WYOMING LIBRARY REMODEL

Job No. 6943.03

AS PER ADDENDUM #1

RECORD SET OF DRAWINGS

City Project No. **6943.03** Zone Map No. **1B** Sheet **18** of **28**
A-401B

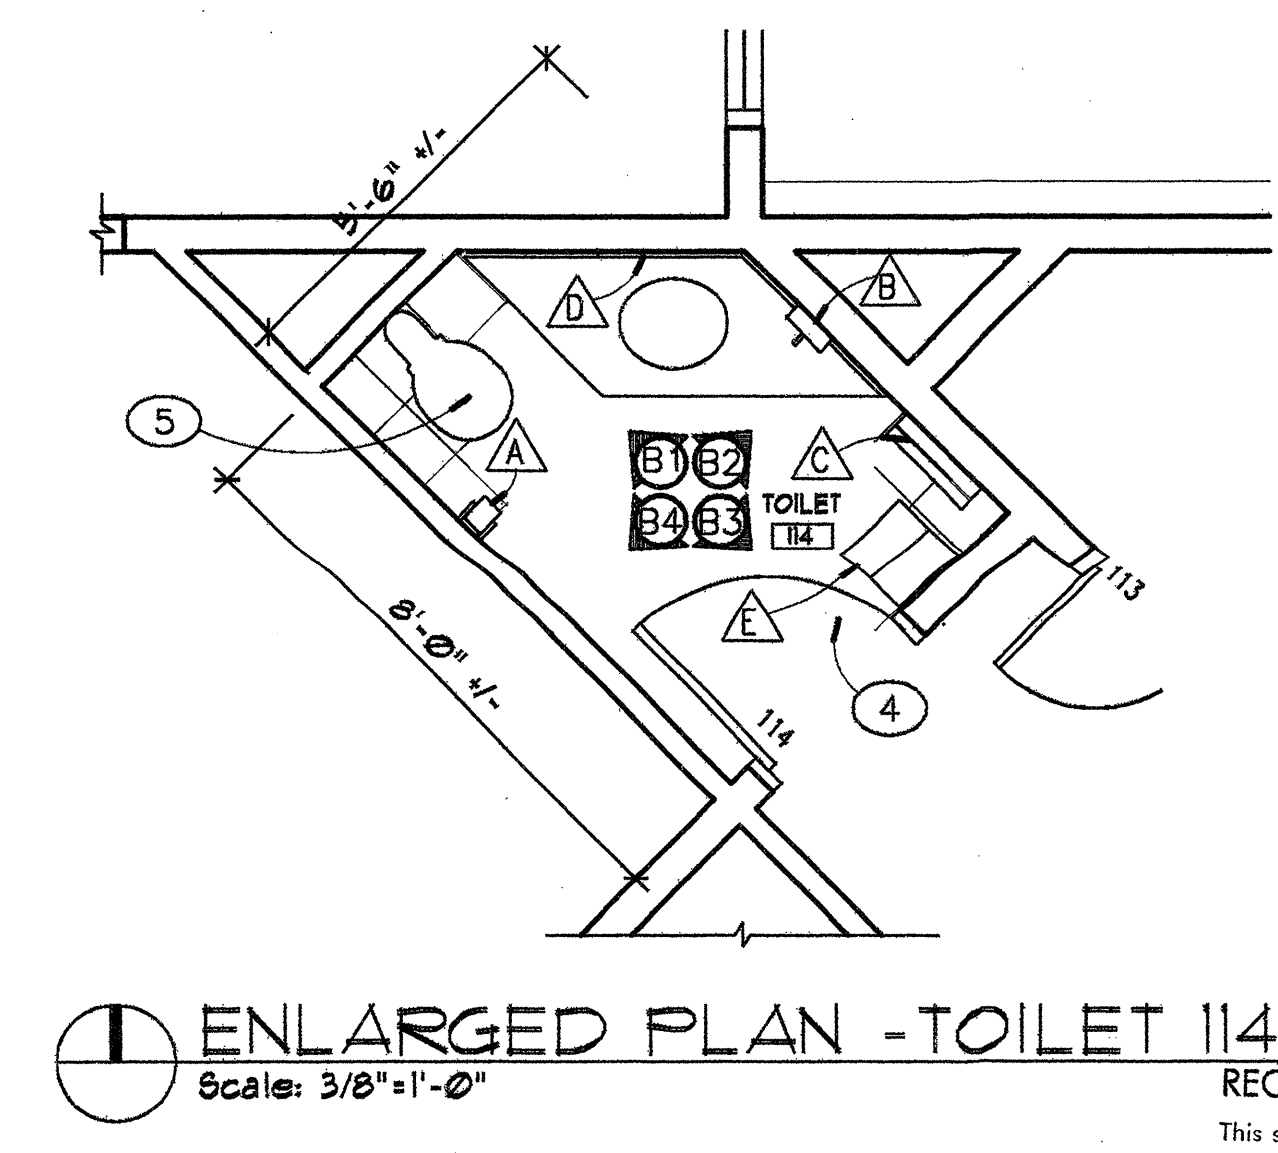
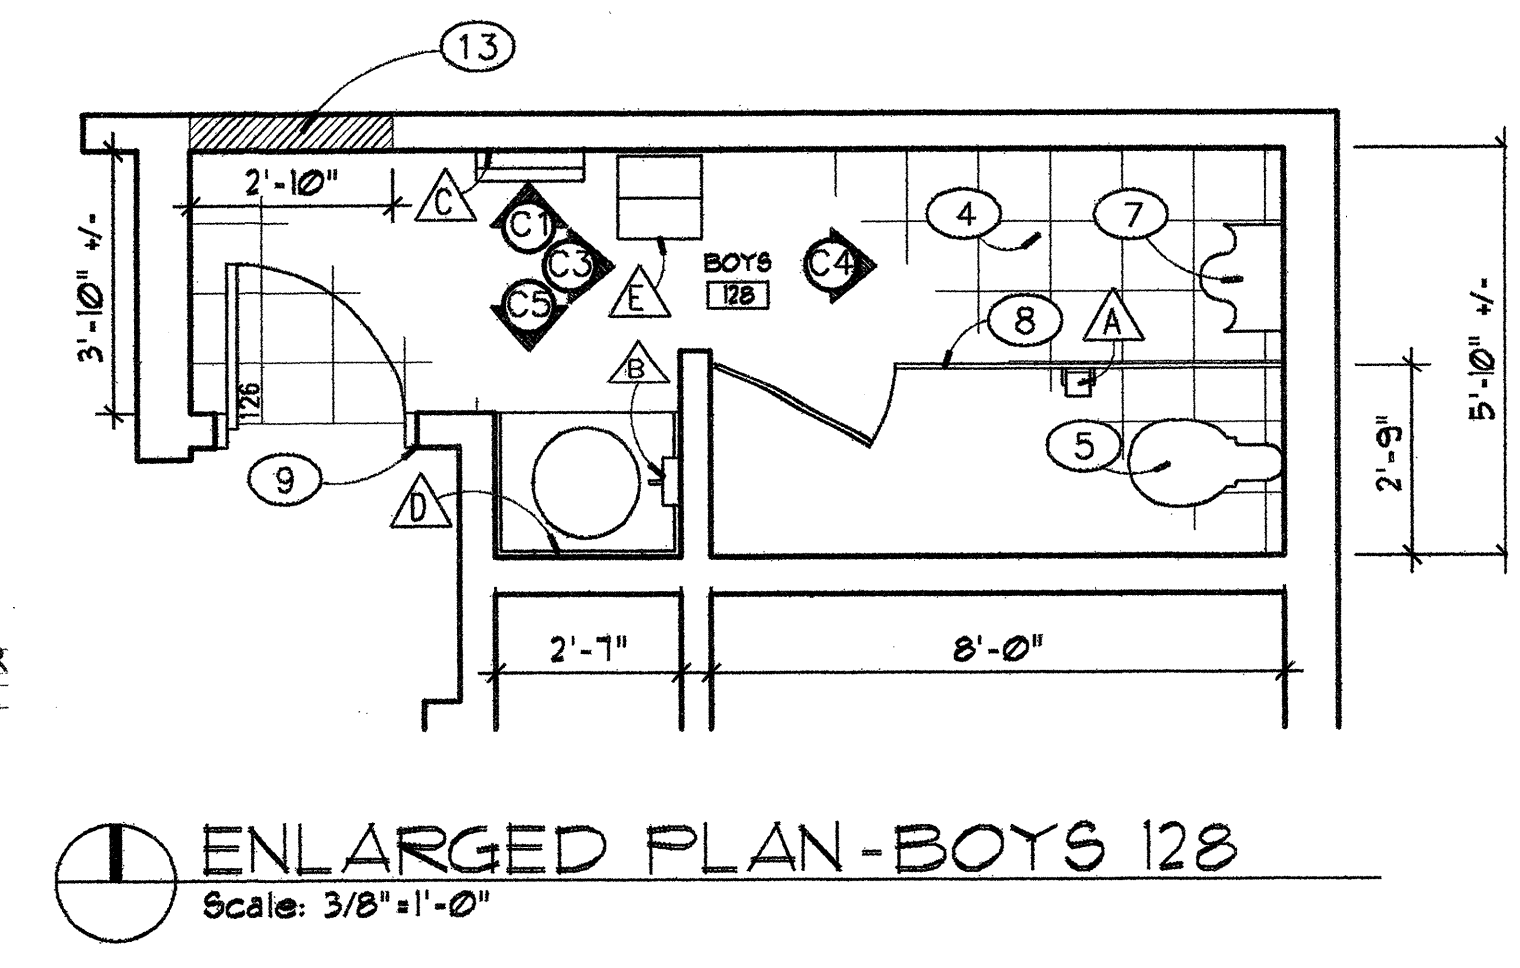
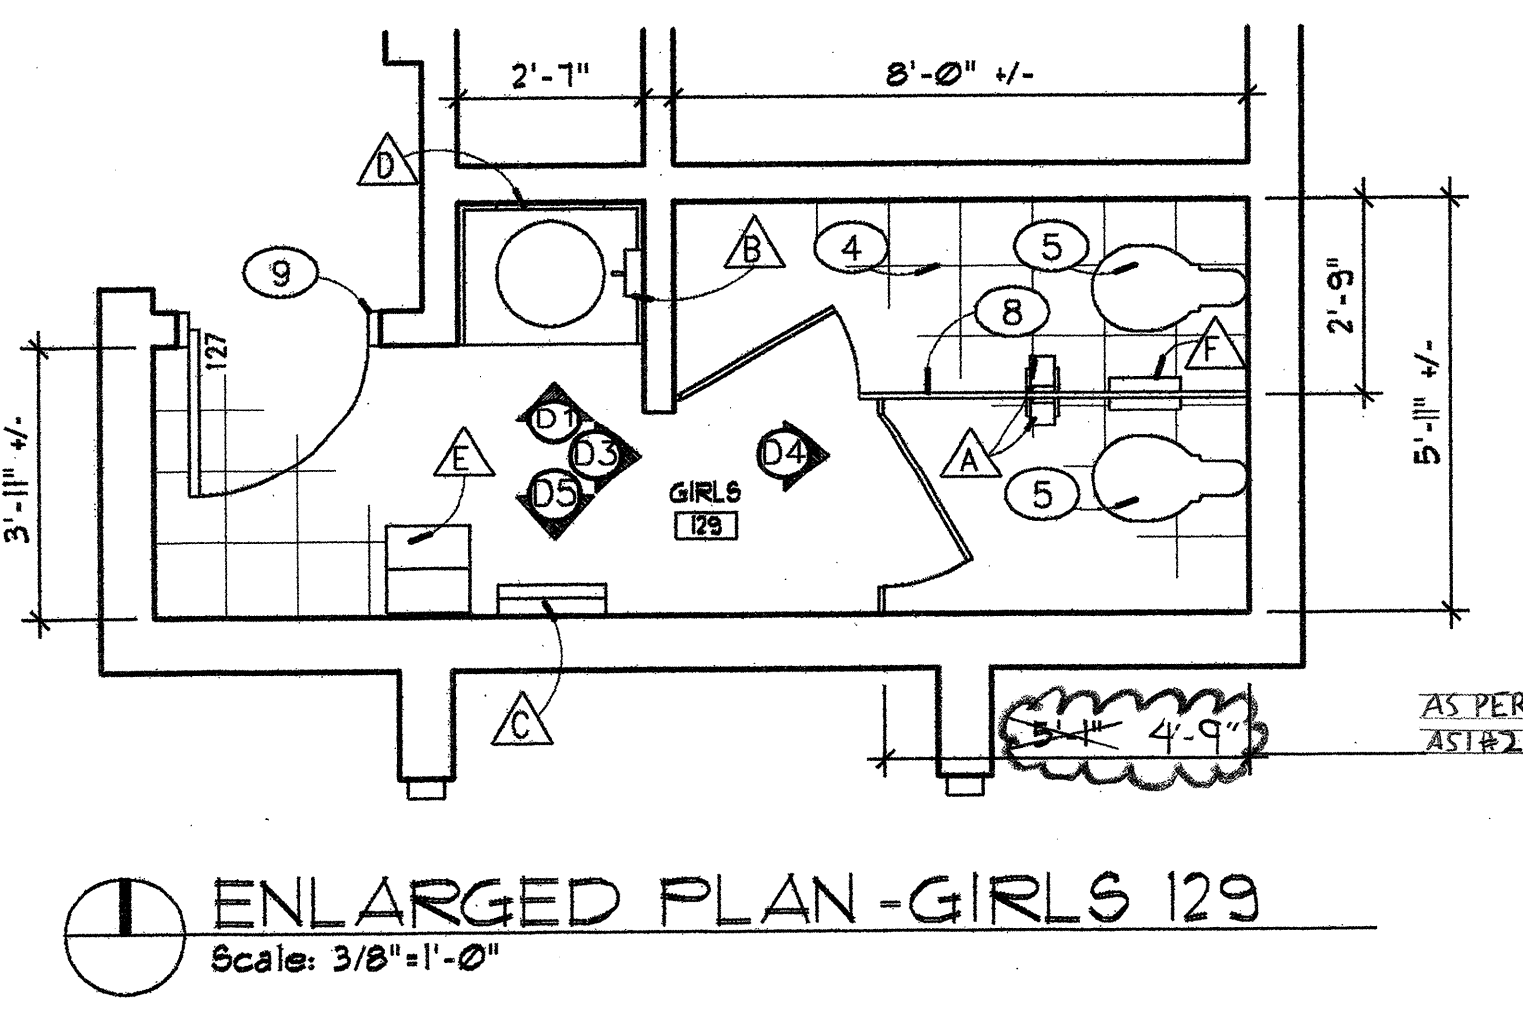
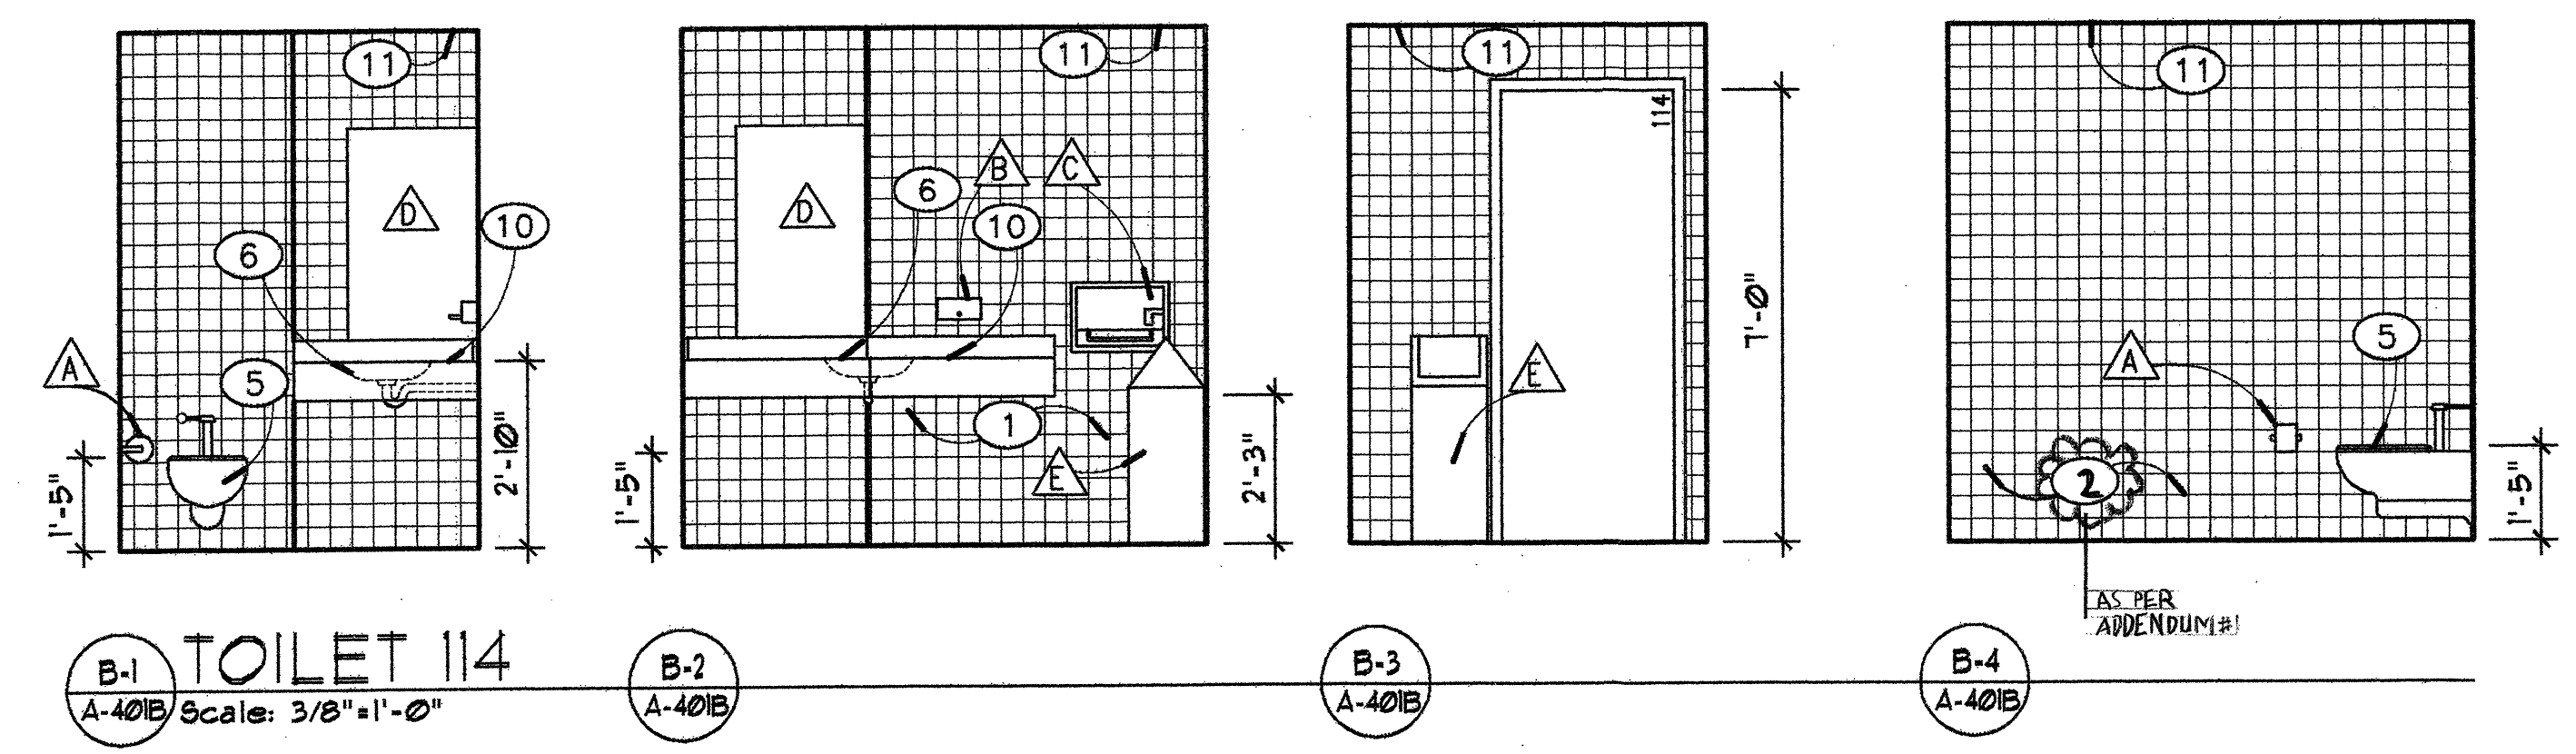
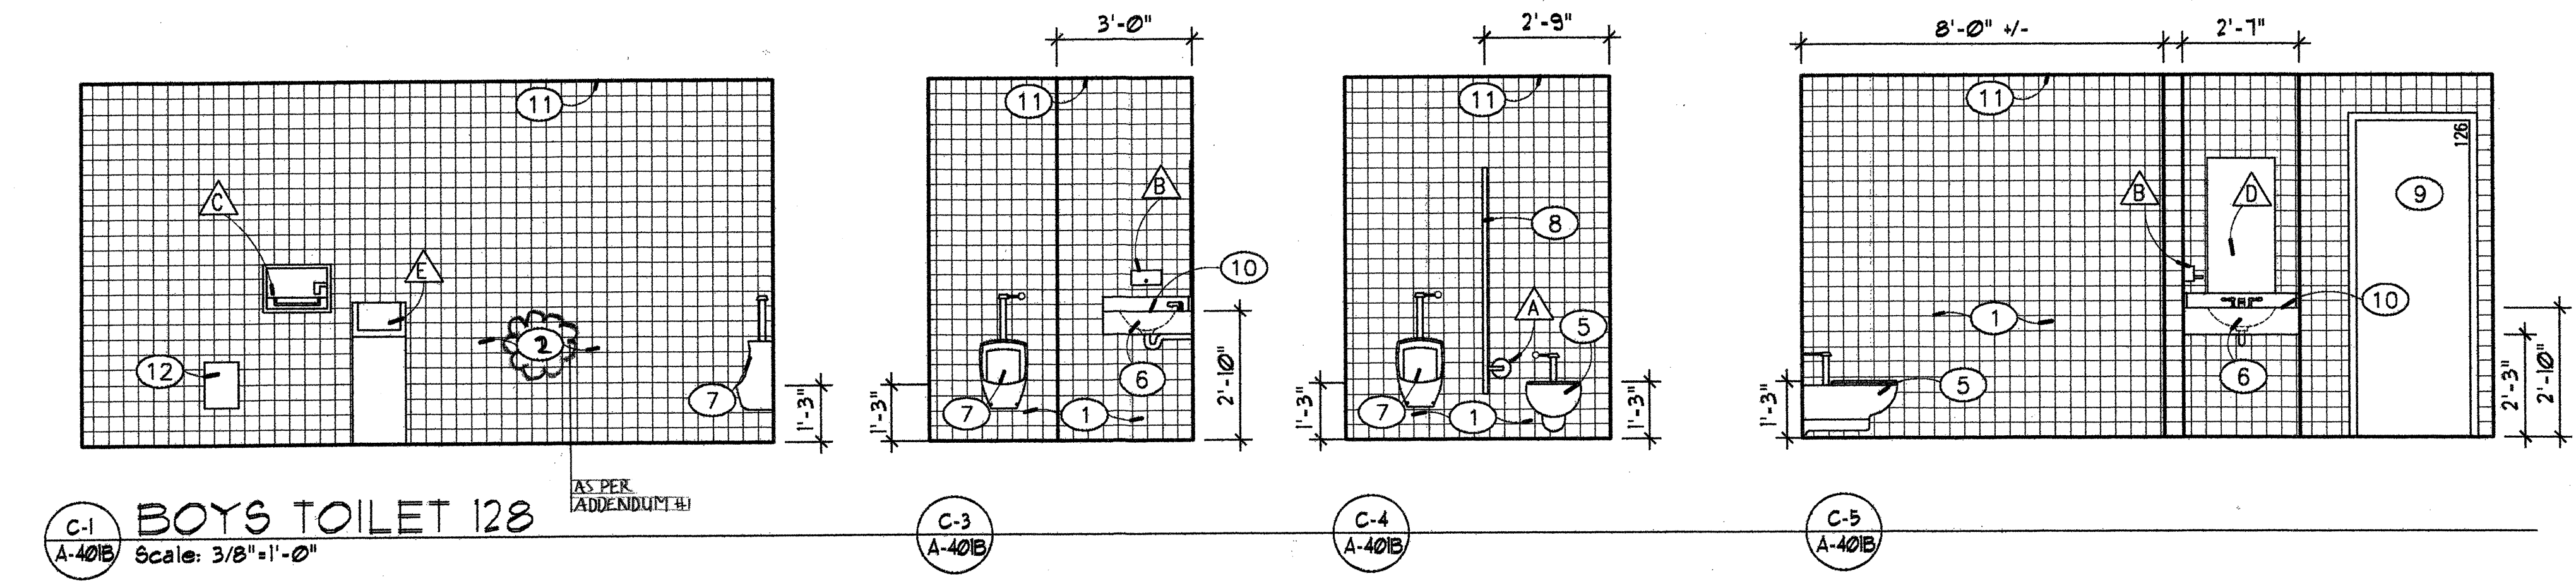
2. KN #3 indicates new 5/8" W.R. Type "X" gyp. brd., tape, texture and paint. It has come to our attention that the restrooms existing gyp. brd. may be reused. We do not want the new ceramic tile installed on just the painted walls. Provide thin chicken wire and staple to the wall to the studs so that the tile and thin set can adhere to the wall, not the paint. This is a tremendous savings in gyp. brd. work, please demo the wall and reinstall as indicated by the 2'-7" dimension at no additional cost to the Owner.
